NOTICE OF MEETING

The City of Lake Elmo
Planning Commission will conduct a meeting on
Monday, August 25, 2014 at 7:00 p.m.

PLANNING COMMISSION
DATE: 8/25/14
AGENDA ITEM: 4A – PUBLIC HEARING
CASE # 2014-41

The City of Lake Elmo has received a request from Lennar Corporation for final plat approval of the second phase of the Savona residential development (Savona 2nd Addition). The final plat includes 47 single family residential lots, 22 single family attached units (townhouses), and the infrastructure necessary to support the future homes on these lots. The City Council approved the Savona Preliminary Plat on August 6, 2013, which covered 113 acres of land within the I-94 Corridor planning area. There are 310 single family and multi-family residential units planned within the entire subdivision, and the final plat covers only a portion of the overall total of units that will eventually be platted. Lennar has finalized its purchase of the land included in the final plat area, and is acting as the sole applicant for this request.

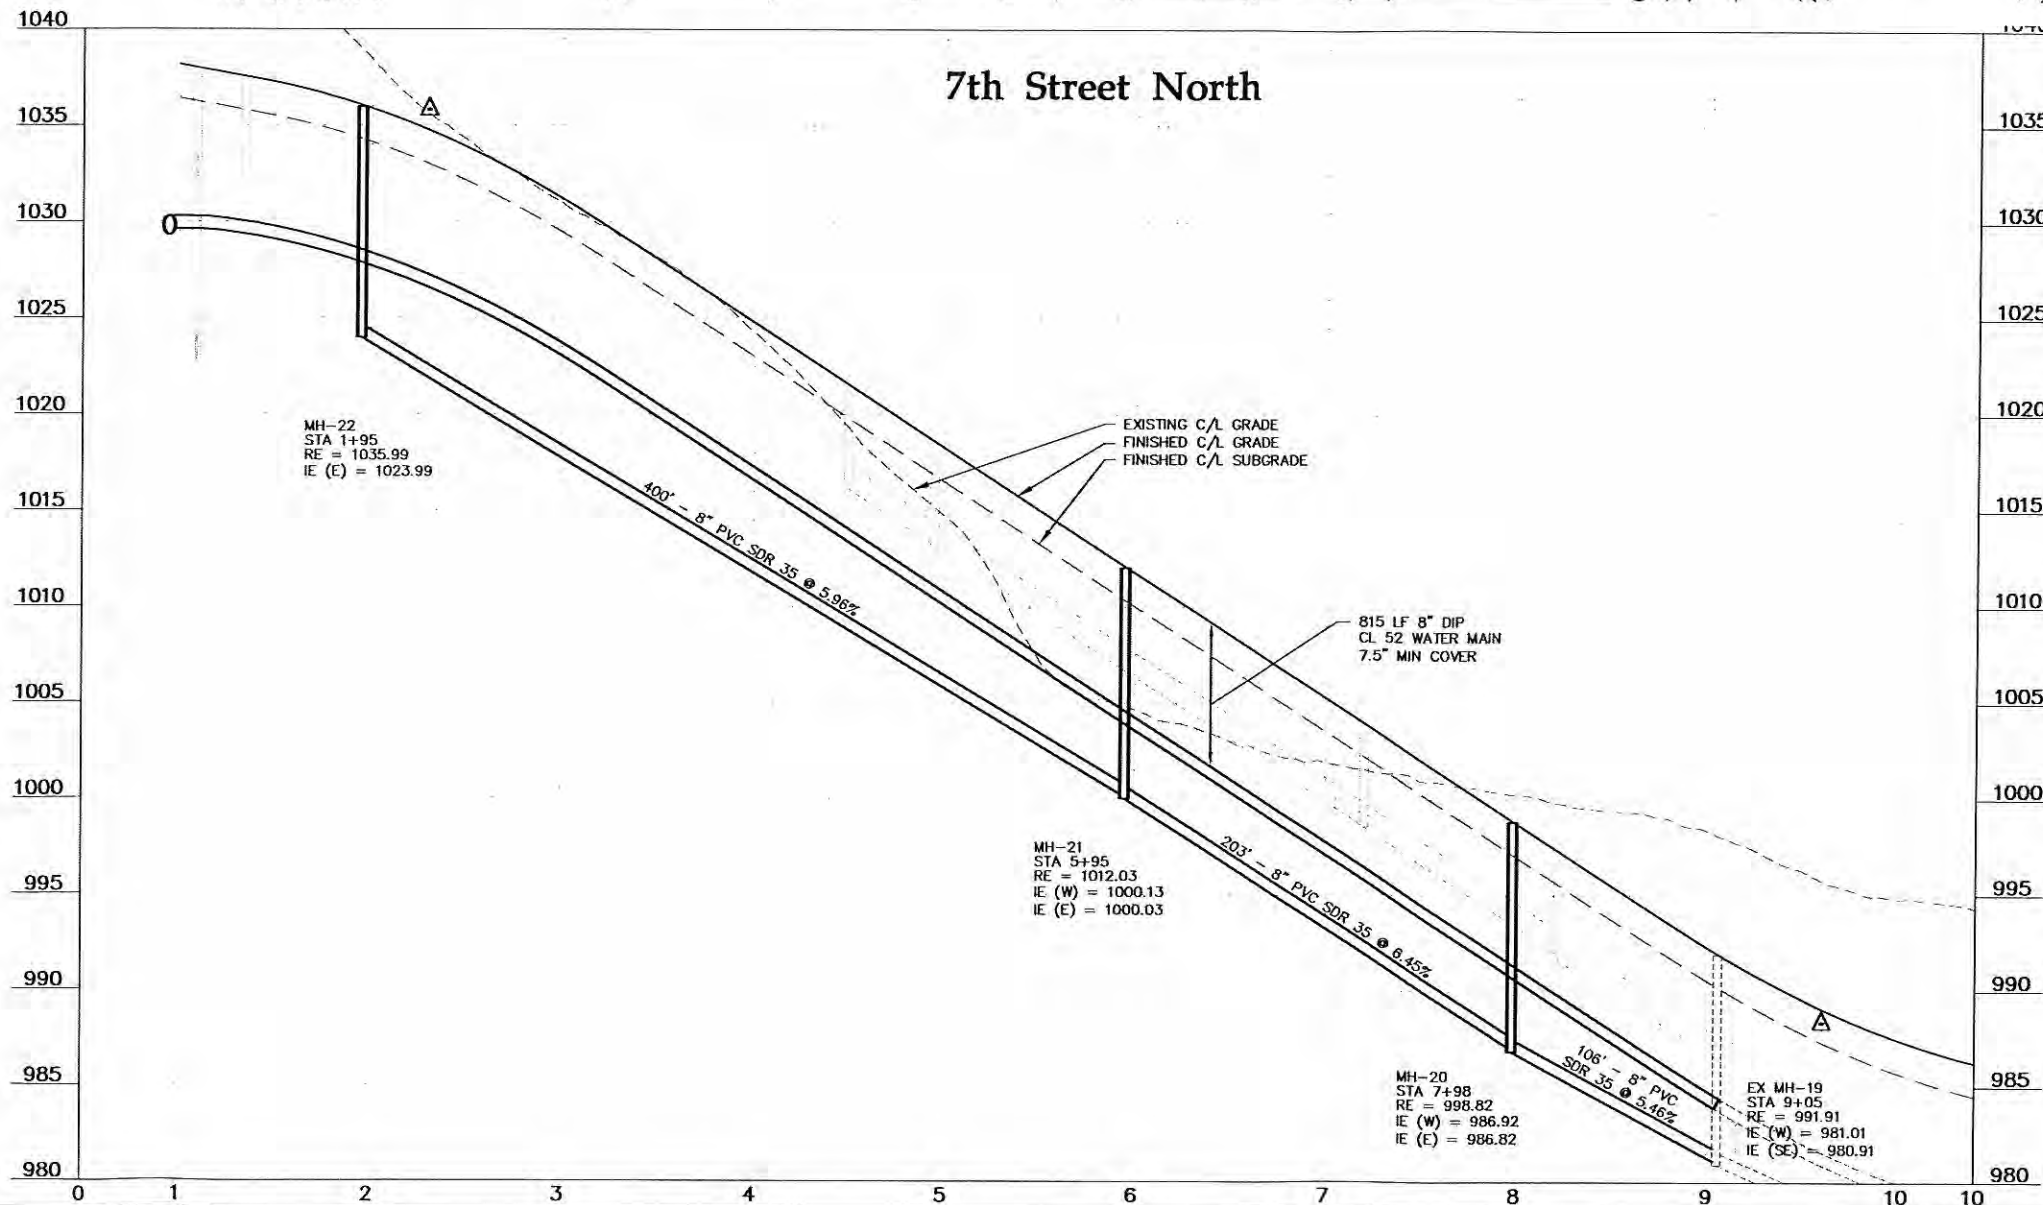
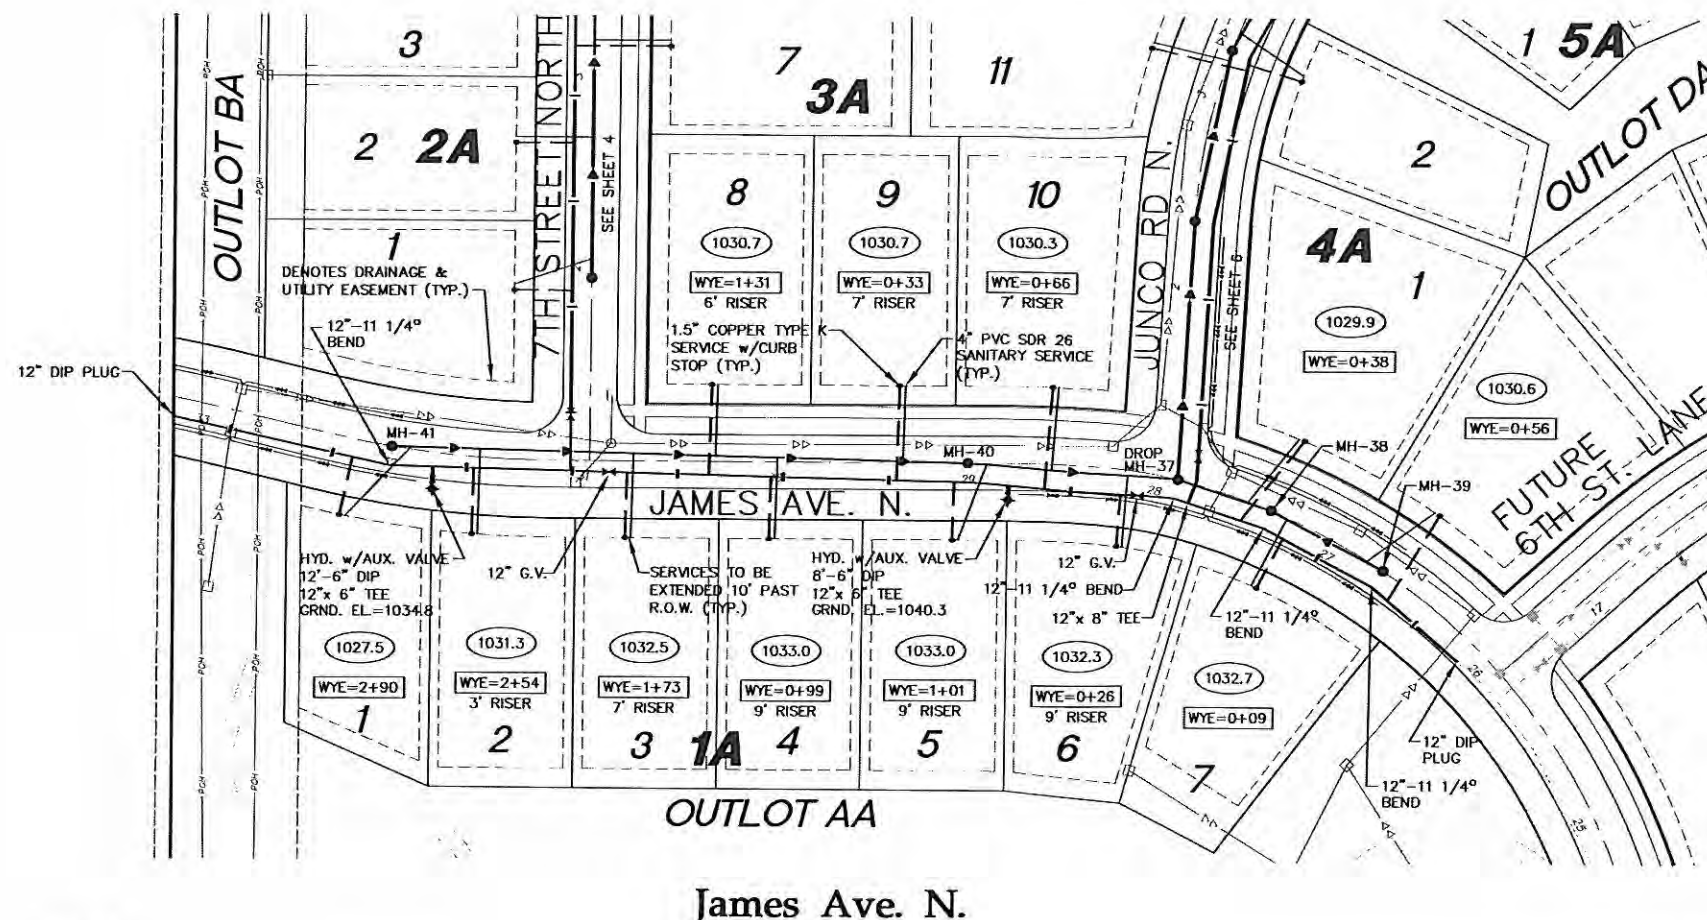
- The water and sewer service stubs for Lot 1, Block 4 should be relocated to serve this lot from Junco Road.
- The water and sewer service stubs to the unnamed lot along the future 6th Street (Sheet 5) must be removed. Services for this lot should be installed from the 6th Street mains as part of a future phase.
